## **Quality Notification – Return Requested**

Western's PF-4-XX and PF2-4-XX families of PTFE-lined flexible hoses with NPT fittings are rated for 3000 psi working pressure and the information tag attached to the hose should reflect this 3000 psi rating. Specifically, these families include the following Western part numbers: PF2-4-18, PF2-4-24, PF2-4-36, PF2-4-48, PF-4-18, PF-4-24, PF-4-36, and PF-4-48.

3000 psi Hose with Incorrect 6000 psi Information

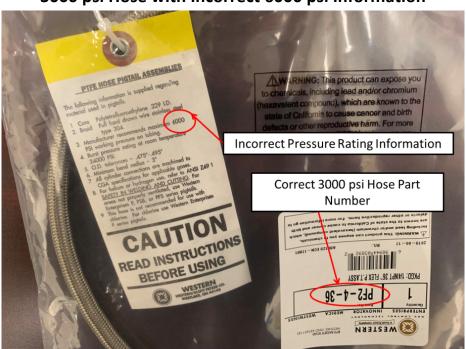
Western has become aware that the information tag on PF-4-XX and PF2-4-XX hose assemblies shipped/invoiced between May 1<sup>st</sup> and June 7<sup>th</sup> 2019 incorrectly indicates a 6000 psi working pressure. Referring to the image below, the hoses are labeled with the correct Western 3000 psi hose part number, but the printing on the information tag incorrectly indicates a 6000 psi working pressure.

Therefore, in an abundance of caution, <u>Western requests that our direct customers and their end customers return any PF-4-XX and PF2-4-XX PTFE-lined flexible hoses received/invoiced between May 1<sup>st</sup> and June 7<sup>th</sup> 2019. Western will re-tag and return the corrected units within 24 hours or if you prefer, Western will provide corrected tags so that you may replace the incorrect tags.</u>
